Amendment 3: Hot Standby and Clock Drift Error Reduction

IEEE Std 802.1ASdm™-2024

(Amendment to IEEE Std 802.1AS™-2020 as amended by IEEE Std 802.1AS™-2020/Cor 1-2021, IEEE Std 802.1ASdr™-2024, and IEEE Std 802.1ASdn™-2024)

Figure 7-4—Time-aware network example for synchronization path redundancy, with one clock source providing time to two domains

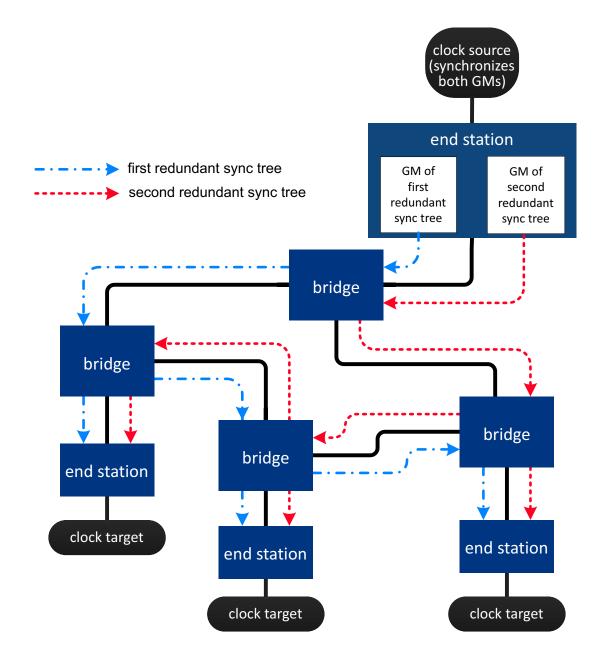
Replace Figure 7-4 with the following figure:

- NOTE 1—The methods used for merging the redundant Sync messages received at each end station are not specified in this standard.
- NOTE 2—All the "bridges" in this figure are examples of time-aware systems that contain PTP Relay Instances, and the end stations are examples of time-aware systems that contain PTP End Instances.
- NOTE 3—GM denotes Grandmaster PTP Instance
- NOTE 4—This figure differs from the 2020 edition of this standard, with IEEE Std 802.1AS-2020/Cor 1-2021, IEEE Std 802.1ASdr-2024, and IEEE Std 802.1ASdn-2024 applied, in that the end station at the top of the figure explicitly shows the two GM PTP Instances and the clock source is indicated as synchronizing both GMs.

Figure 7-5—Time-aware network example for GM redundancy with one primary GM and one secondary GM, which are separated in two gPTP domains

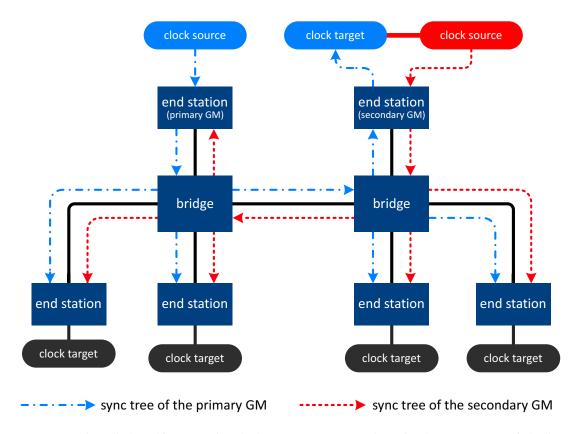
Figure 7-5 shows an example network with two redundant GMs, one as primary GM and the other as secondary GM, where each GM has one of the two redundant synchronization trees originating from it. This example supports hot-standby operating mode. In this mode, the secondary GM has to be synchronized to the primary GM, because it is part of the synchronization tree of the primary GM as shown in the figure. The secondary GM does not start sending Sync messages until it is synchronized to the primary GM.

Replace Figure 7-5 with the following figure:

Figure 7-6—Time-aware network example for hot standby with both GM and partial path redundancy

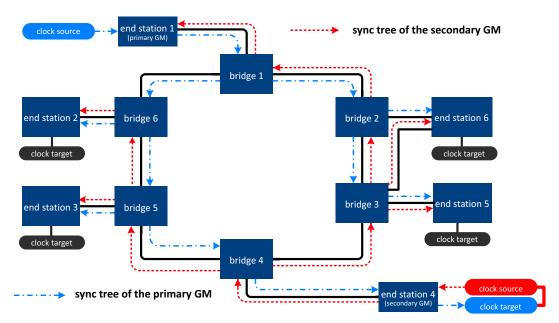
Insert 7.2.5 (including a new Figure 7-6) after 7.2.4 as follows:

Figure 7-6 shows an example of a time-aware network with hot standby (see Clause 18). The network has GM redundancy and path redundancy to all of the Bridges and end stations 1, 4, and 6 (path redundancy for end stations 2, 3, and 5 is possible, but is not illustrated to avoid clutter in the figure). In addition, for simplicity the optional split functionality (see 18.5.3.4) is assumed to be disabled.

End station 1 is the primary GM (see Clause 18), and its synchronization spanning tree is illustrated by the arrows of the primary grandmaster sync tree. End station 4 is the secondary GM, and its synchronization spanning tree is illustrated by the arrows of the secondary grandmaster sync tree. Except for the links to end stations 2, 3, and 5, the network can tolerate the failure of any single link and the Bridges and end stations remain synchronized by either the primary or the secondary GM. For example, if the link between bridge 3 and end station 6 fails, end station 6 is still synchronized by the primary domain via bridge 2. If the link between bridge 5 and bridge 6 fails, bridge 6 is still synchronized by the primary domain and bridge 5 is synchronized by the secondary domain. If the secondary GM fails, all the Bridges and end stations are still synchronized by the primary GM.

Figure 7-8—Model for a PTP Instance and its interfaces to higher-layer applications model

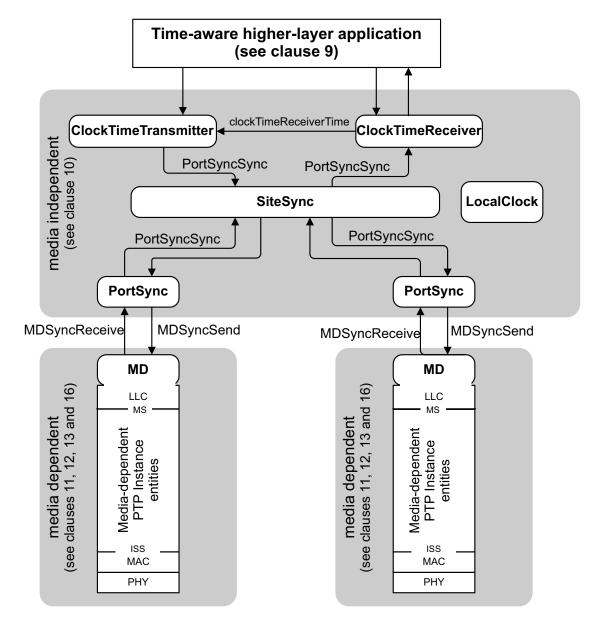
Change the first paragraph of 7.4 and the caption of Figure 7-8 as follows:

Change the title of Figure 7-8 (as amended by IEEE Std 802.1ASdr-2024) as shown on the following page:

Figure 10-6—Clock Time Transmitter Sync Offset state machine

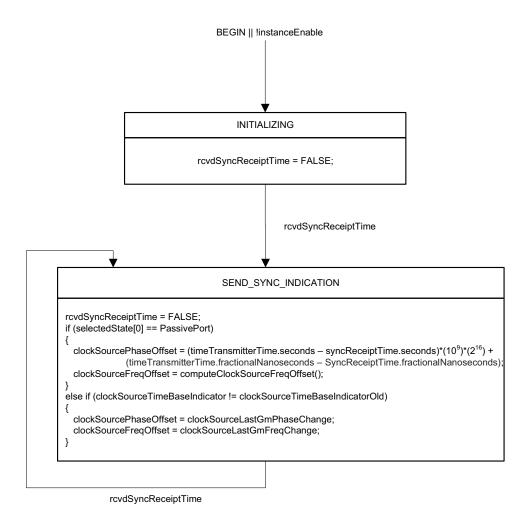
Replace Figure 10-6 (as amended by IEEE Std 802.1ASdr-2024) with the following figure:

Figure 10-9—ClockTimeReceiverSync state machine

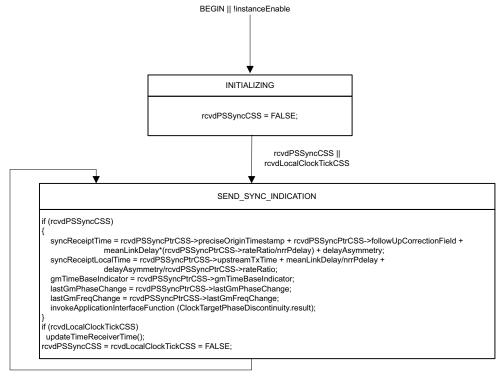
Replace Figure 10-9 (as amended by IEEE Std 802.1ASdr-2024) with the following figure:

Figure 10-12—External port configuration state machines—overview and interrelationships

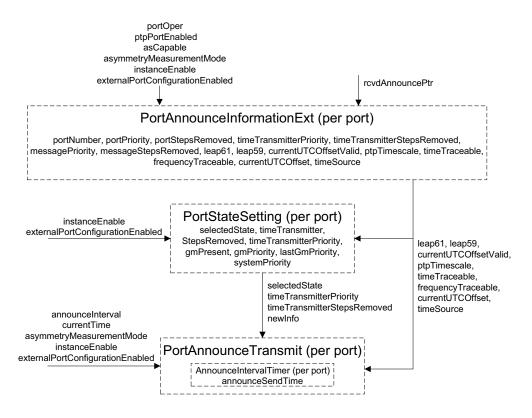
Replace Figure 10-12 (as amended by IEEE Std 802.1ASdr-2024) with the following figure:

Figure 10-16—PortAnnounceInformationExt state machine

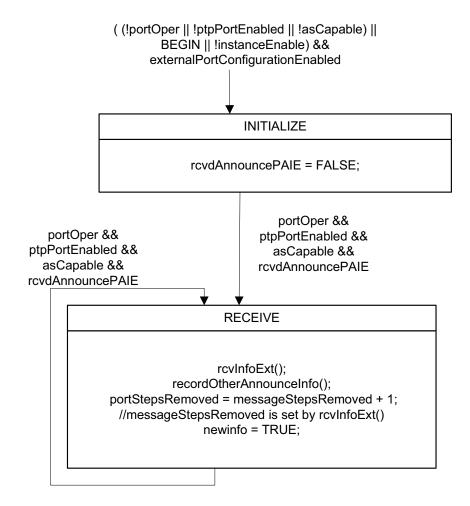
Replace Figure 10-16 with the following figure:

Figure 10-17—PortStateSettingExt state machine

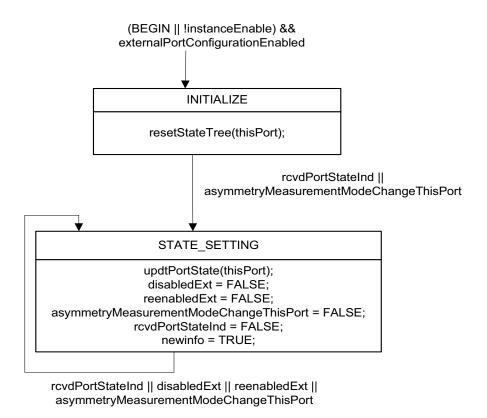
Replace Figure 10-17 with the following figure:

Figure 10-18—PortAnnounceTransmit state machine

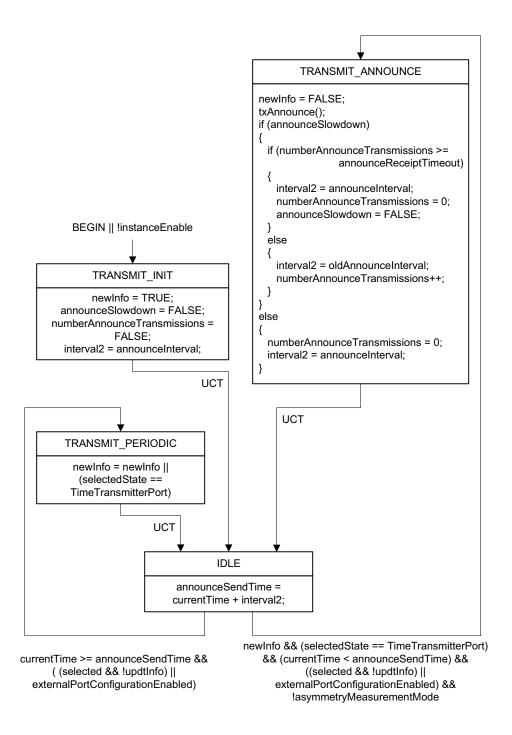
Replace Figure 10-18 (as amended by IEEE Std 802.1ASdr-2024) with the following figure:

NOTE—This figure differs from the 2020 edition of this standard, with Corrigendum 1 and IEEE Std 802.1ASdr-2024 applied, in that the statement interval2 = announceInterval is added after the existing statements in the TRANSMIT_INIT state.

Figure 10-19—AnnounceIntervalSetting state machine

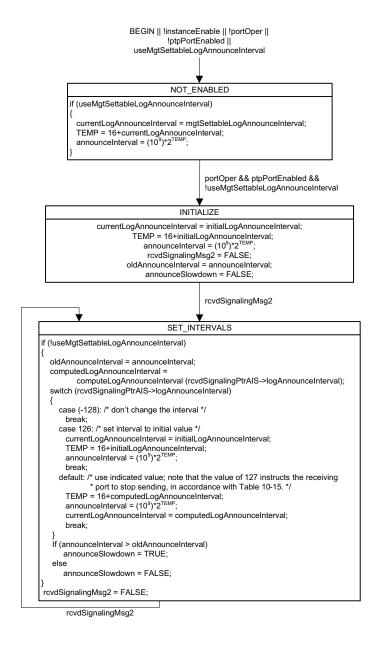
Replace Figure 10-19 (as amended by IEEE Std 802.1AS-2020/Cor 1-2021) with the following figure:

NOTE—This figure differs from the 2020 edition of this standard, with Corrigendum 1 applied, in that the variable LogAnnounceInterval at the end of line five of the SET_INTERVALS state is changed to logAnnounceInterval (i.e., the capitalization is corrected), and the statement oldAnnounceInterval = announceInterval is added immediately after the first open curly brace in the SET_INTERVALS state.

Figure 10-20—SyncIntervalSetting state machine

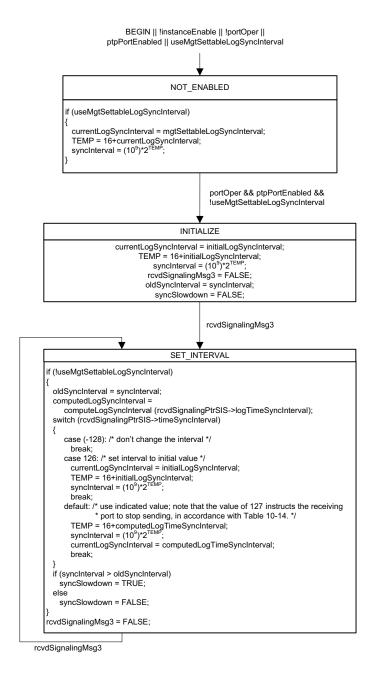
Replace Figure 10-20 (as amended by IEEE Std 802.1AS-2020/Cor 1-2021) with the following figure:

NOTE—This figure differs from the 2020 edition of this standard, with Corrigendum 1 applied, in that the statement oldSyncInterval = syncInterval is added immediately after the first open curly brace in the SET_INTERVALS state.

Figure 10-21—GptpCapableTransmit state machine

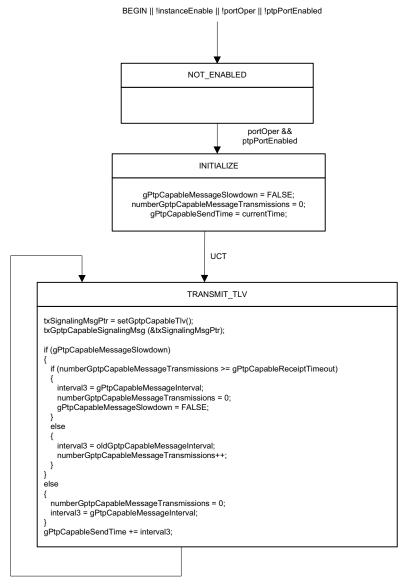
Replace Figure 10-21 with the following figure:

Figure 10-22—GptpCapableReceive state machine

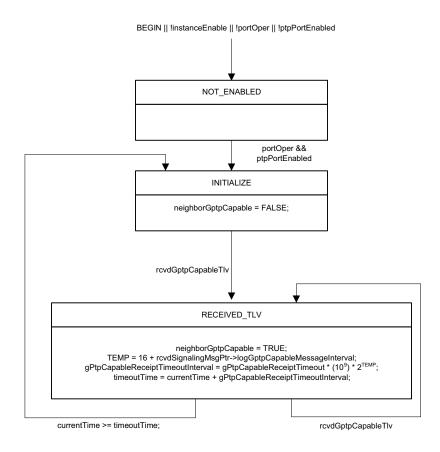
Replace Figure 10-22 with the following figure:

NOTE—This figure differs from the 2020 edition, with Corrigendum 1 applied, of this standard in that the condition !domainEnabled is removed from the set of logical ORs at the ingress of the NOT_ENABLED state.

Figure 10-23—GptpCapableIntervalSetting state machine

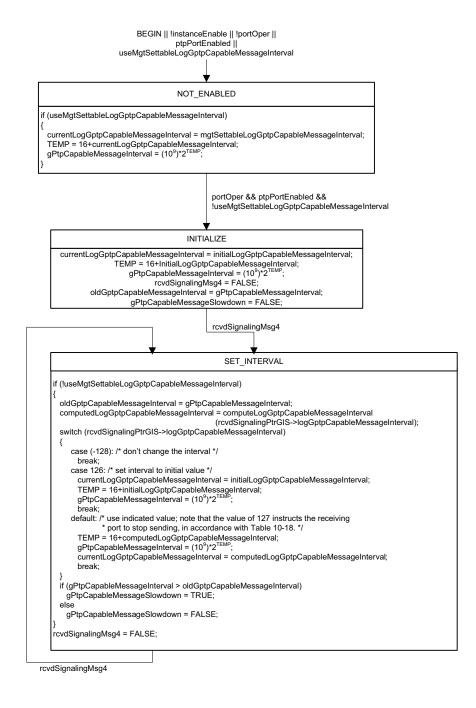
Replace Figure 10-23 (as amended by IEEE Std 802.1AS-2020/Cor 1-2021) with the following figure:

Figure 11-6—MDSyncReceiveSM state machine

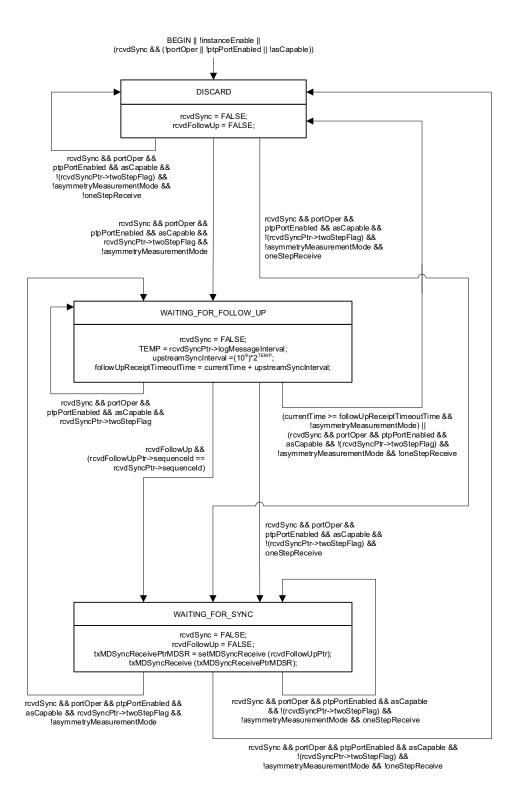
Replace Figure 11-6 with the figure on the following page:

Figure 11-7—MDSyncSendSM state machine

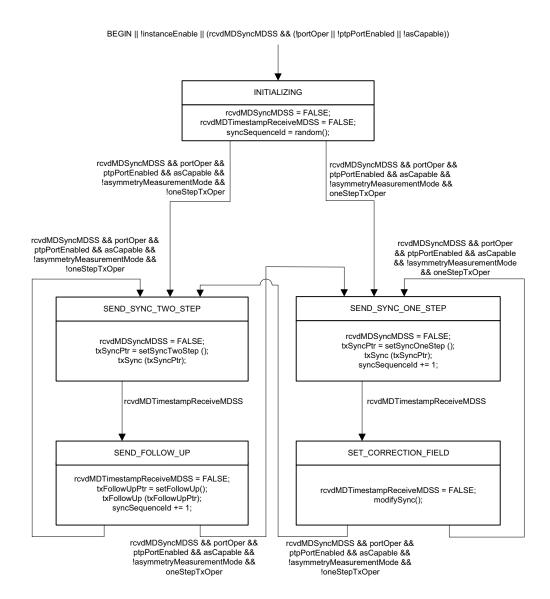
Replace Figure 11-7 with the following figure:

Figure 11-9—MDPdelayReq state machine

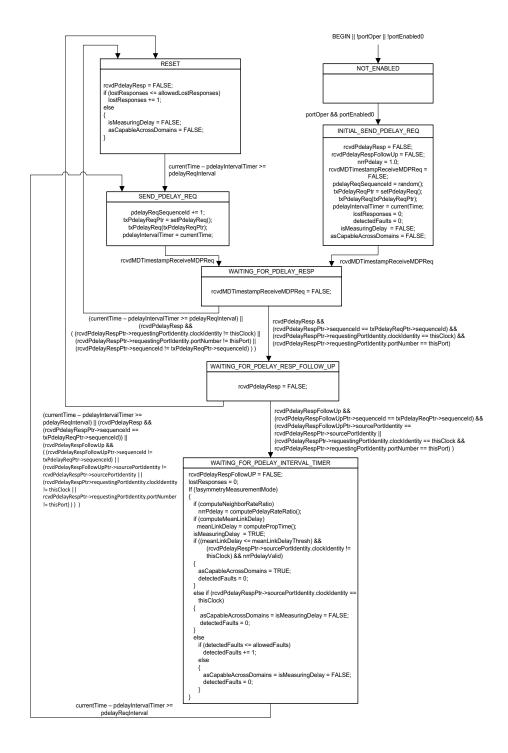
Replace Figure 11-9 (as amended by IEEE Std 802.1AS-2020/Cor 1-2021) with the figure on the following page:

NOTE—This figure differs from the 2020 edition of this standard, with Corrigendum 1 applied, in that (a) the condition "else if (rcvdPdelayRespPtr -> sourcePortIdentity.clockIdentity != thisClock)" in the state WAITING_FOR_PDELAY_INTERVAL_TIMER is changed to

Figure 17-1—Overview of YANG tree

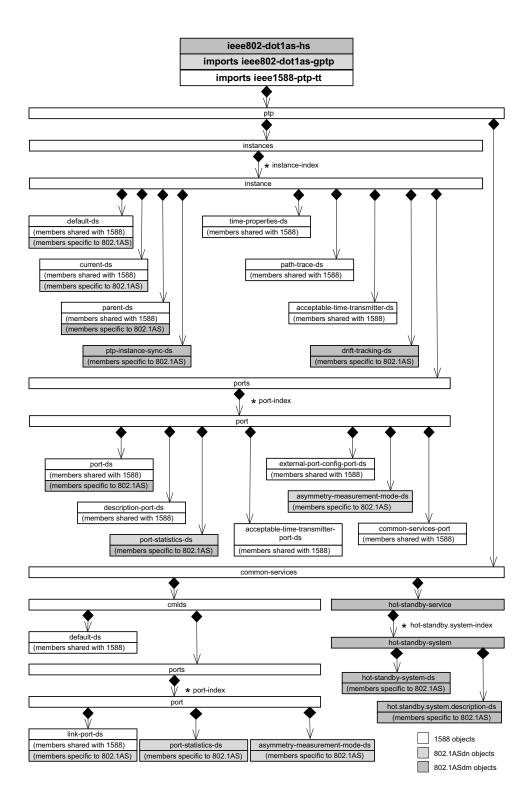
Replace Figure 17-1 with the figure on the following page:

Figure 17-2—PTP Instance detail

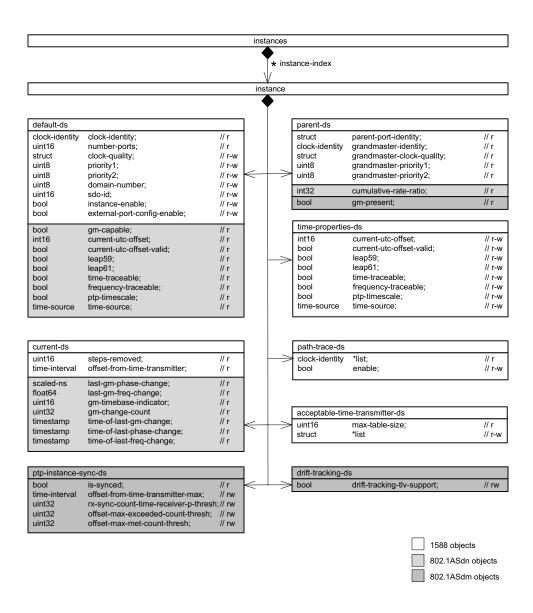
Replace Figure 17-2 with the following figure:

NOTE—This figure differs from the 2020 edition of this standard with Corrigendum 1 applied and as amended by IEEE Std 802.1ASdn in that managed objects needed for the hot standby and Drift_Tracking TLV features are added.

Figure 17-3—PTP Port detail

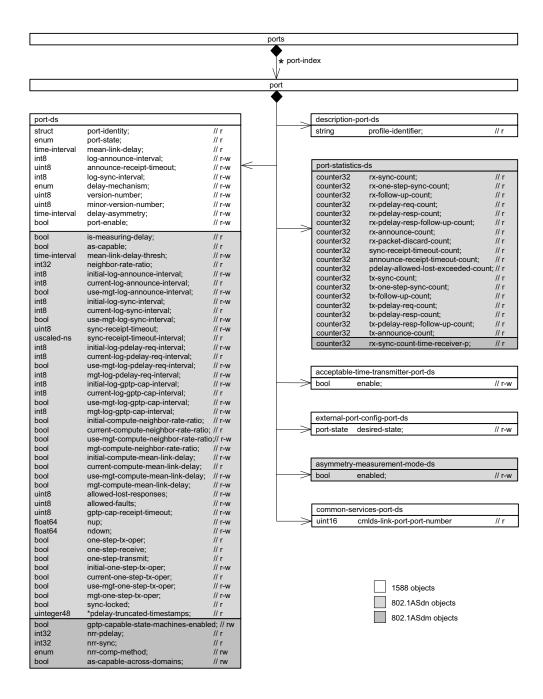
Replace Figure 17-3 with the following figure:

NOTE—This figure differs from the 2020 edition of this standard with Corrigendum 1 applied and as amended by IEEE Std 802.1ASdn in that managed objects needed for the hot standby and Drift Tracking TLV features are added.

Figure 17-4—Common services detail

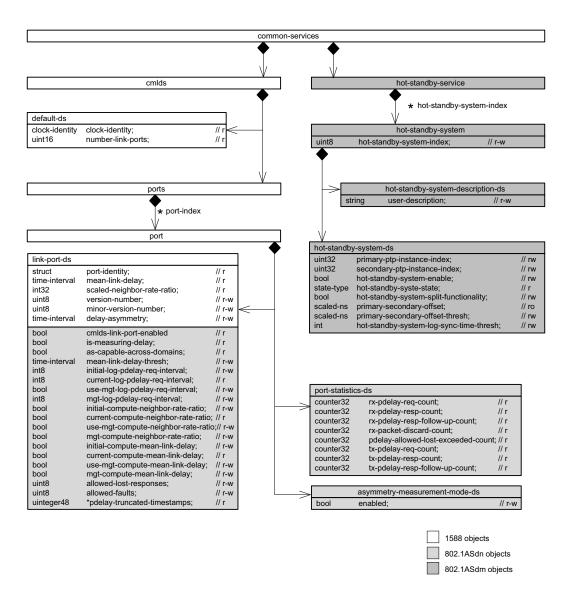
Replace Figure 17-4 with the following figure:

NOTE—This figure differs from the 2020 edition of this standard with Corrigendum 1 applied and as amended by IEEE Std 802.1ASdn in that managed objects needed for the hot standby and Drift Tracking TLV features are added.
